Sunnyside Cogeneration Associates

RE: Sunnyside Refuse and Slurry C/007/0035
Permit Amendment – East Access Road - W

Title: East Haul Road - W

Proposed Haul Road W to the east. Remove Pit Road L. Other Minor Adjustments / updates

Sunnyside Cogeneration Associates
ROAD CLASSIFICATION MAP

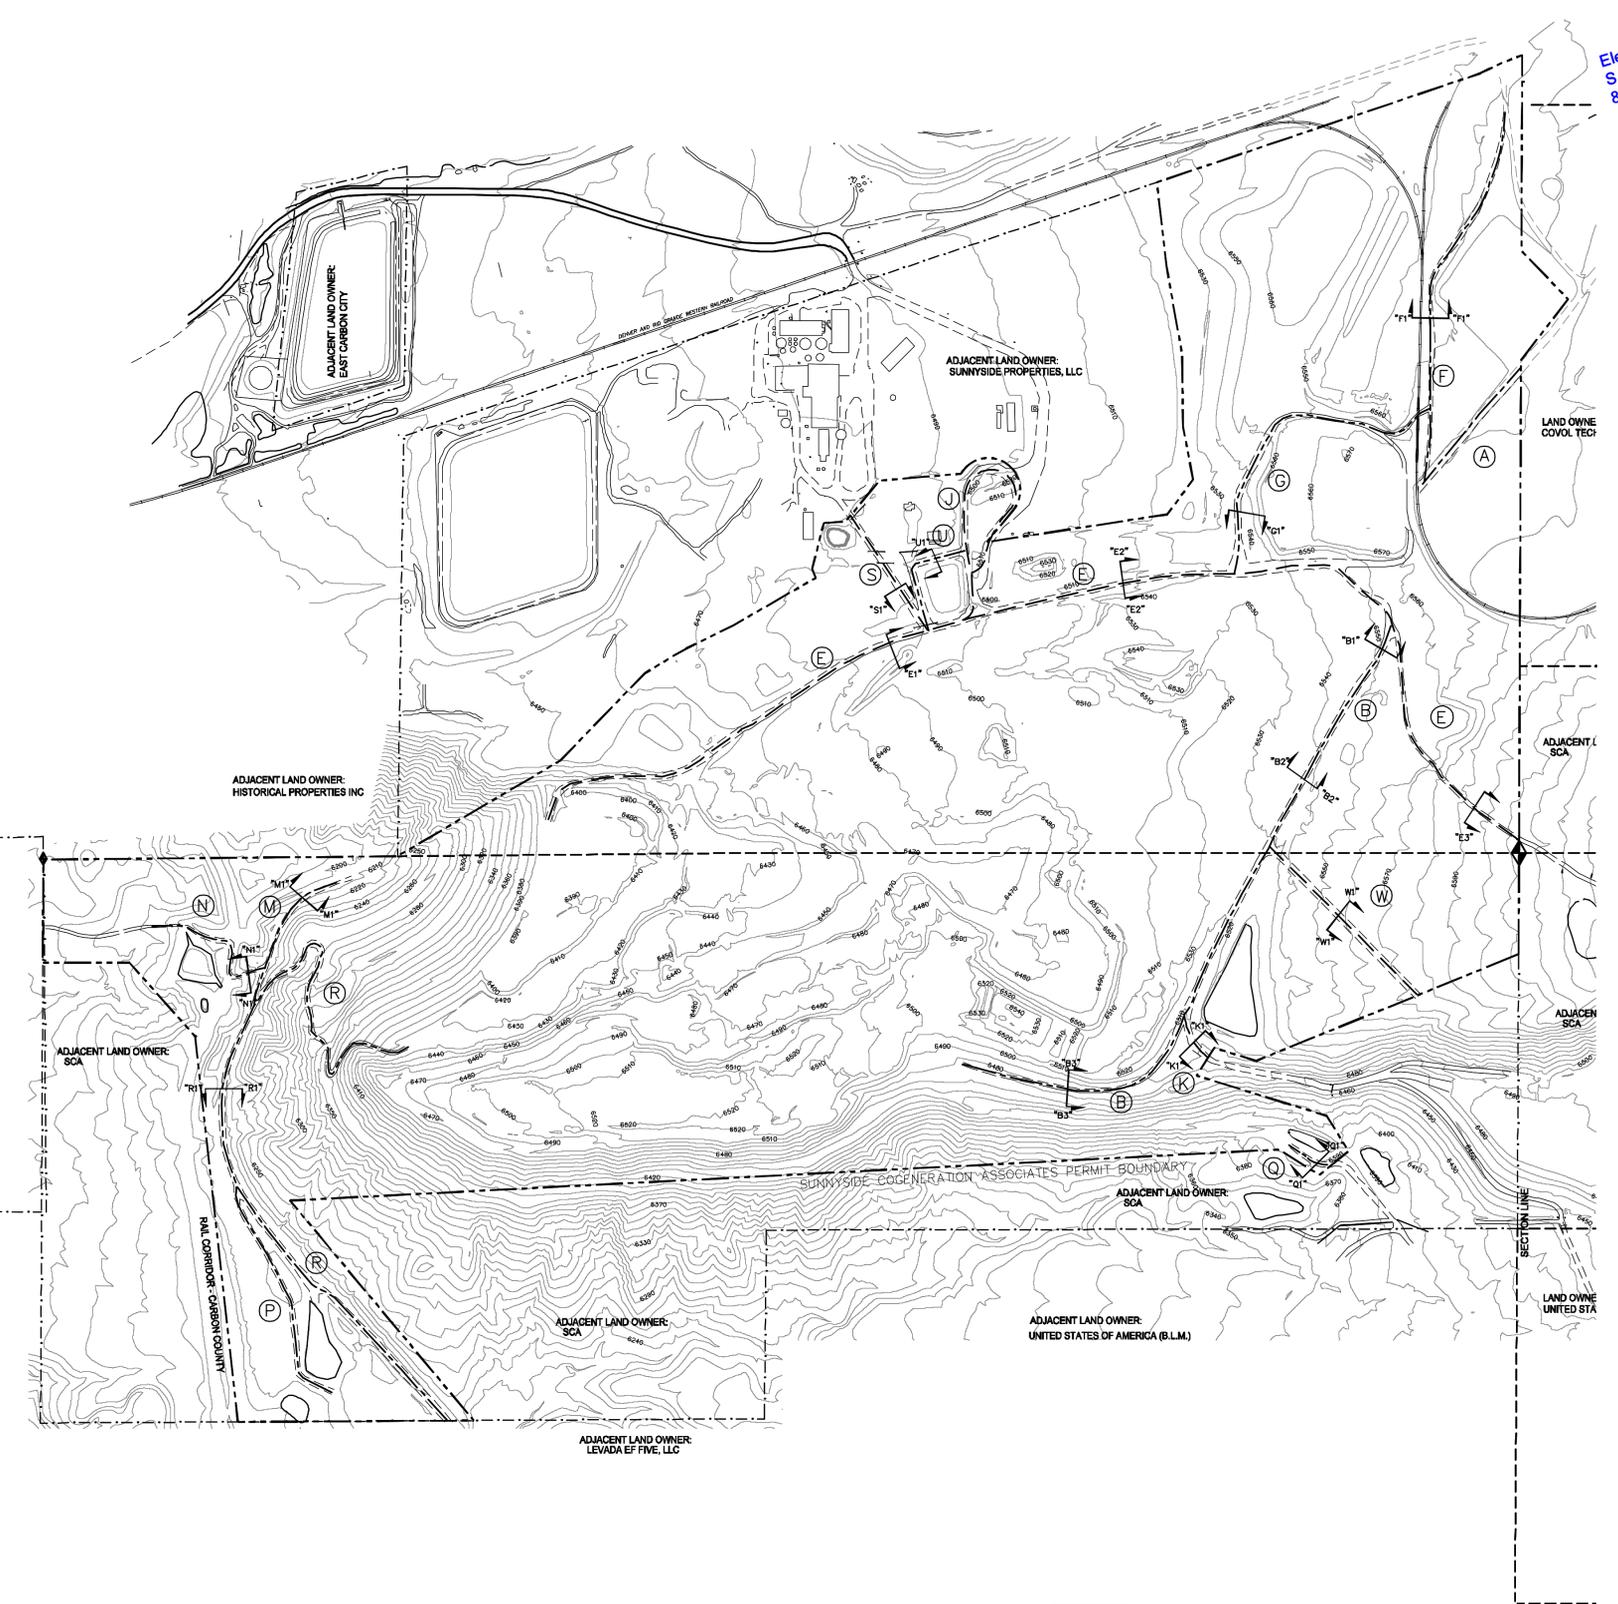
Road W is a proposed primary haul road towards the east or southeast portion of the permit area. It is intended to allow access for offsite activities to cross through the permit area. Grading and regular maintenance will occur during periods of operations on this road. This road is proposed to cross through a future disturbed area (reclamation borrow area) which has already been included in the bond, hence no new reclamation area needs to be added to the bond.

REV	DATE	DESCRIPTION	BY	APP'D
1	7/17	UPDATED TOPO AND ADDED ROAD W	AH	
2	12/16	ADD ROAD U	AH	
3	8/16	SHORTEN ROAD B AND EXTEND ROAD E REMOVE RD T	AH	
4	1/16	ROAD RECLAMATION UPDATES	AH	
5	7/15	WEST PASTURE AND REFUSE PILE ACCESS ROADS	AH	
6	11/10	BOUNDARY AND TOPO UPDATE	AH

Sunnyside Cogeneration Associates
 PLAN AND PROFILES
 ROADS "K", "Q" & "W"

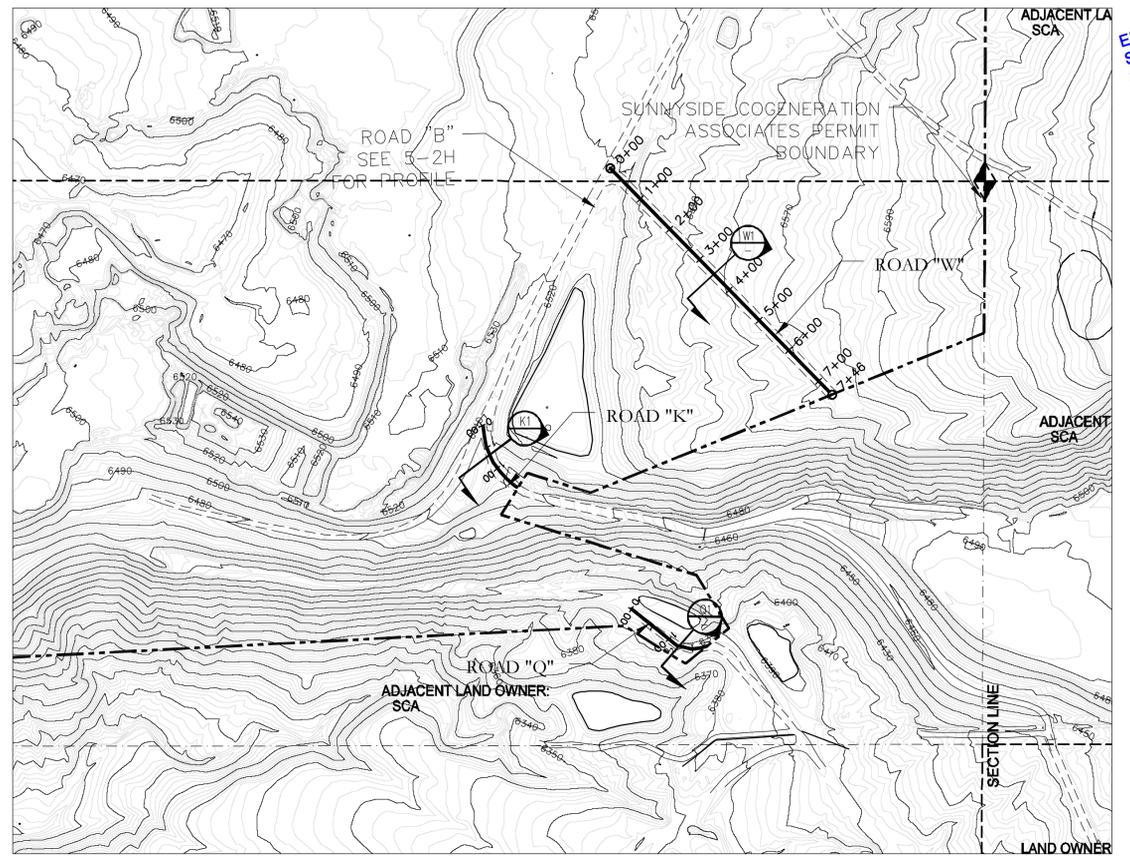
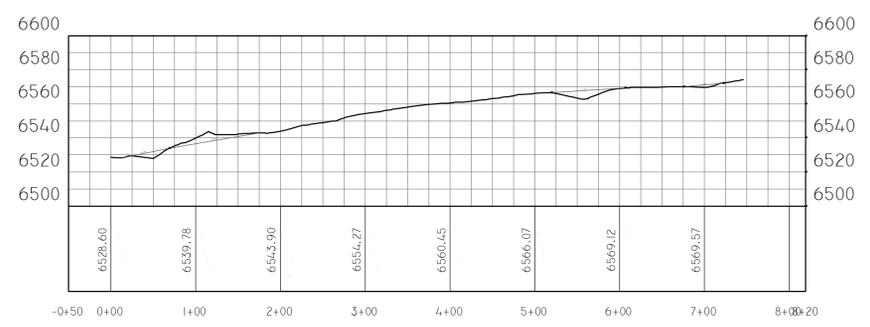
EAST ACCESS ROAD (ROAD W) - PROFILE

REV	DATE	DESCRIPTION	BY	APP'D
△	8/17	UPDATE BNDRY AND TOPO, REMOVE ROAD L ADD ROAD W	AH	
△	11/10	BOUNDARY AND TOPO UPDATES	AH	
△	9/02	2002 PERMIT RENEWAL	PAM	
△	9/97	PERMIT RENEWAL-UPDATE	CAC	
△	2/94	CHANGE IN ROAD B & SECTIONS	AH

**Sunnyside Cogeneration Asso
HYDROLOGIC INDEX MAP**

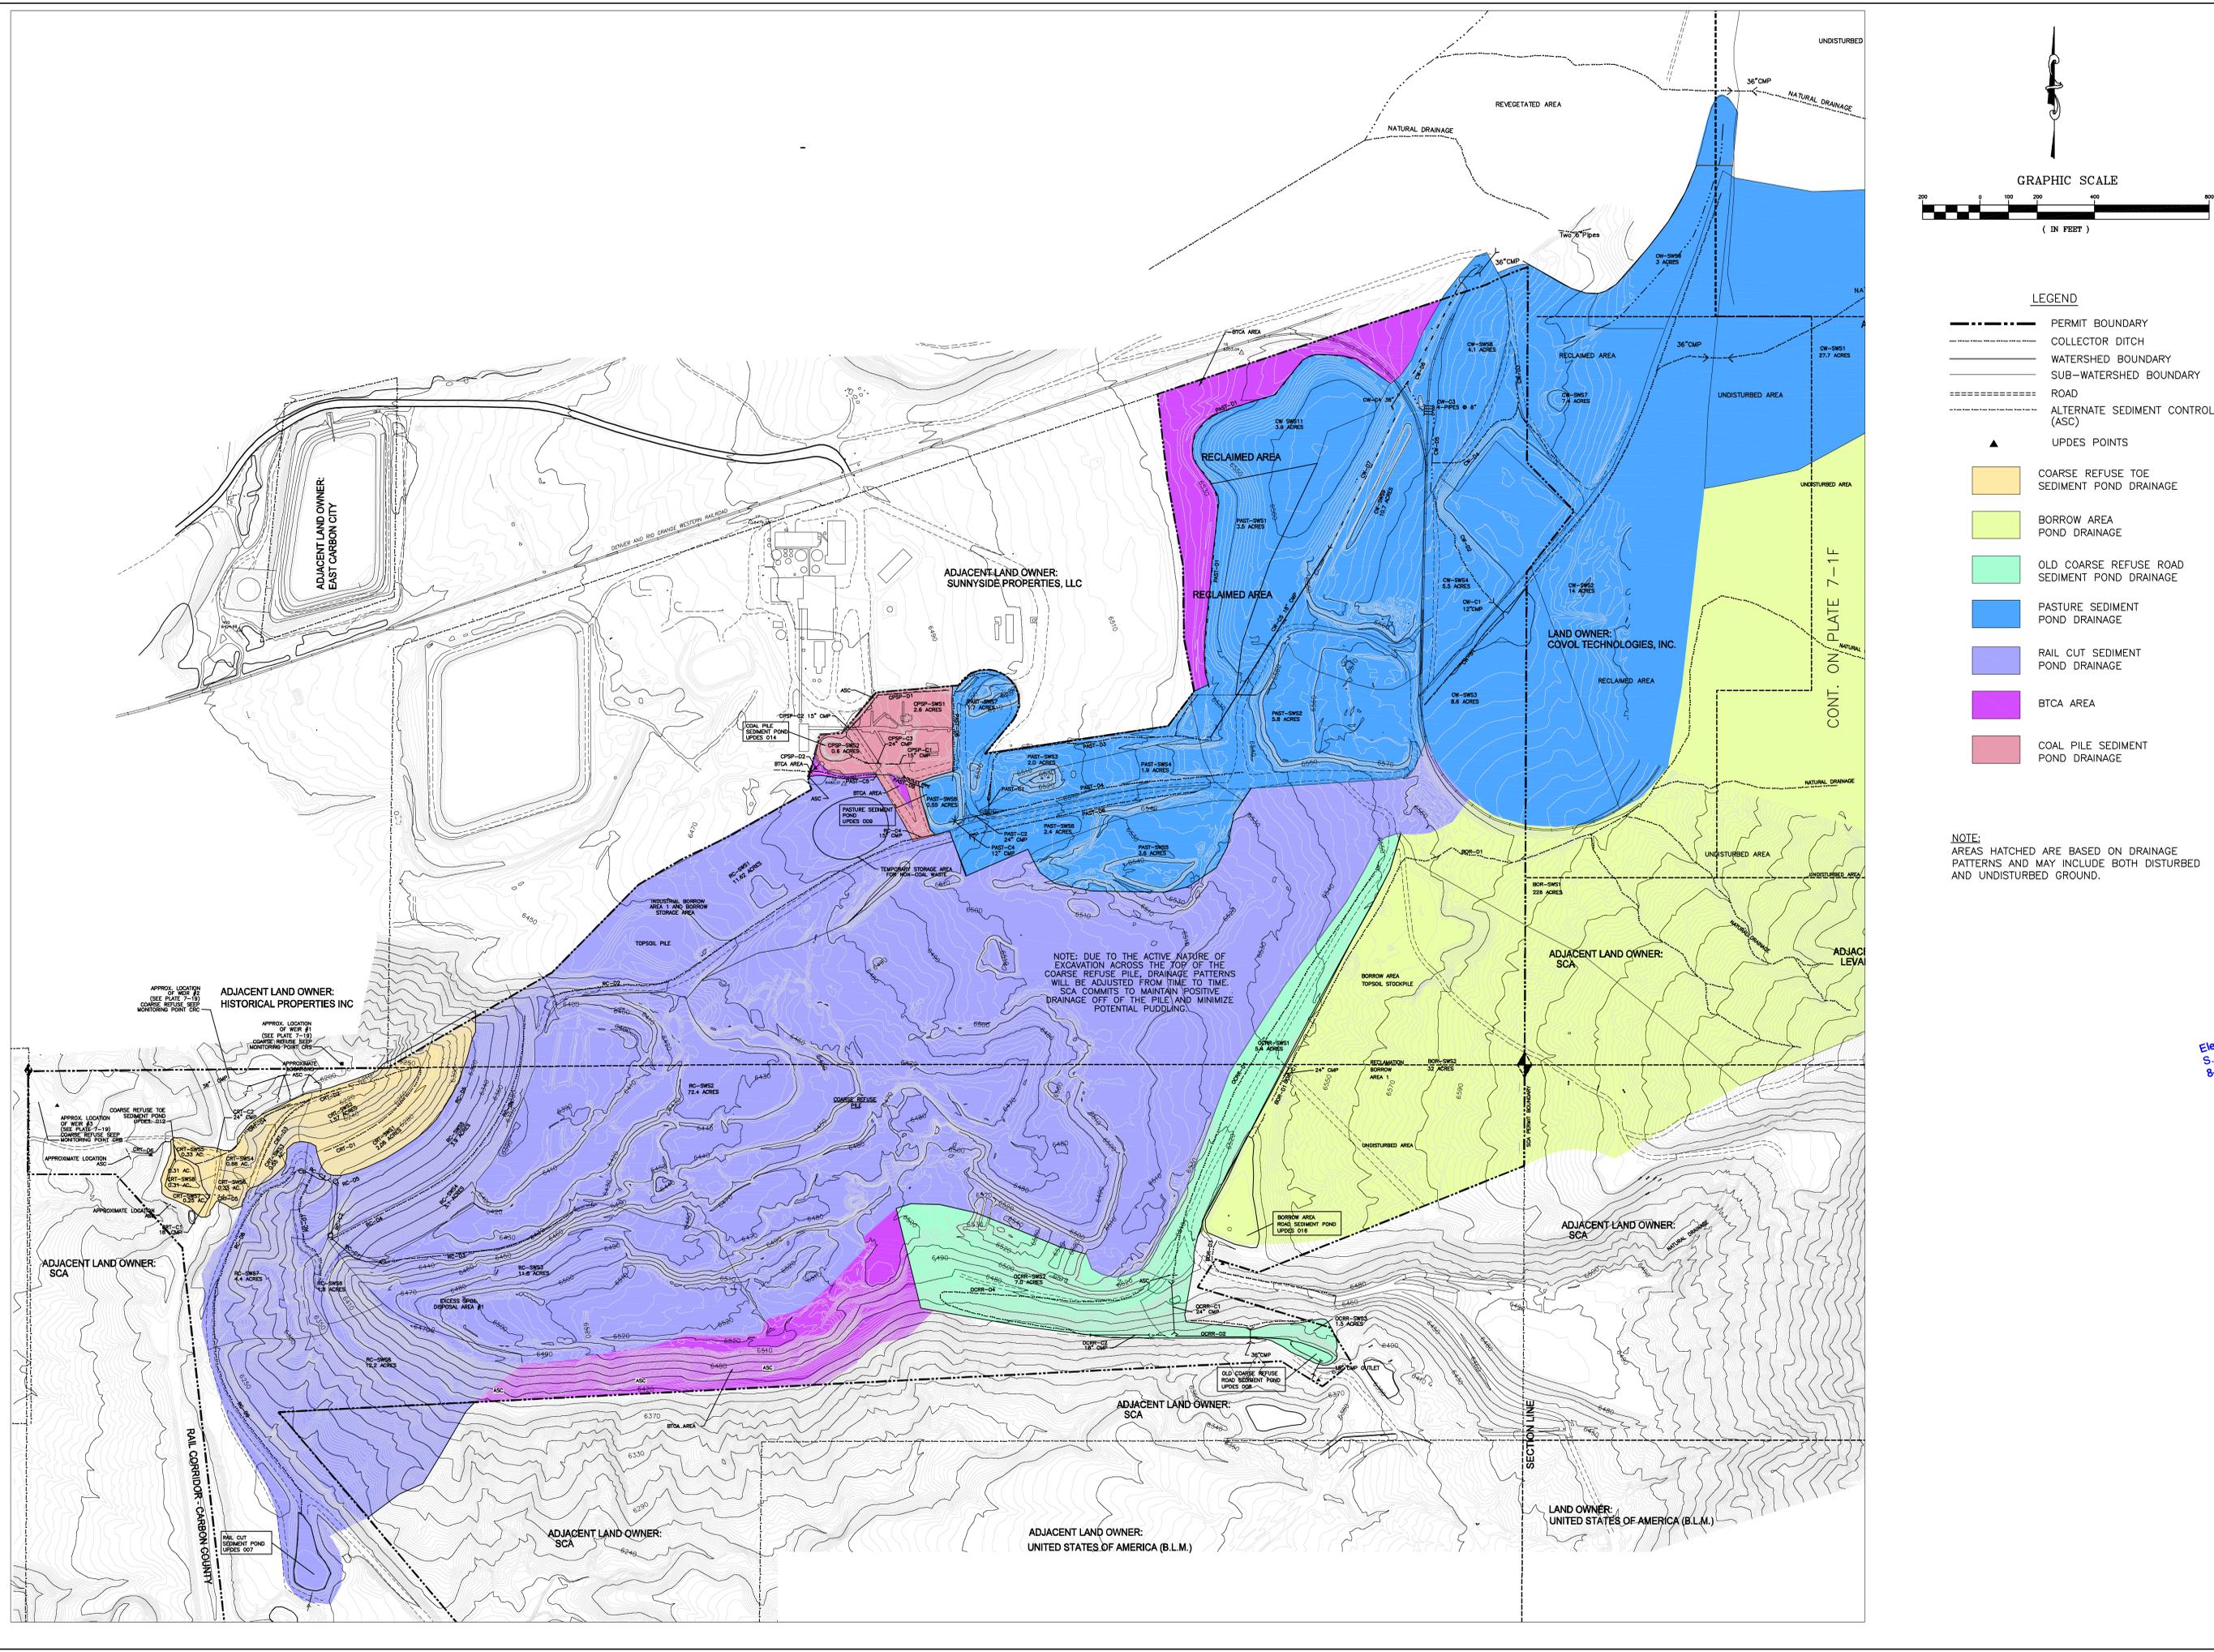
DATE	DESCRIPTION	BY	APP'D
7/17	UPDATED TOPO AND ADDED ROAD W	AH	AH
10/16	POST CONSTRUCTION UPDATE FOR ROAD S	AH	AH
1/16	EXCESS SOIL DISPOSAL AREA RECLAMATION UPDATE	AH	AH
7/15	REMOVE CULVERTS IN PASTURE POND DRAINAGE AREA	AH	AH
	ADD DITCHES AND CULVERTS IN RAIL CUT DRAINAGE	AH	AH
11/10	BOUNDARY UPDATE	AH	AH
8/10	UPDATE SITE AND TOPO	AH	AH
5/08	MOVE PASTURE POND CULVERT-C1	SSC	AH
5/07	UPDATE PASTURE POND	AH	AH
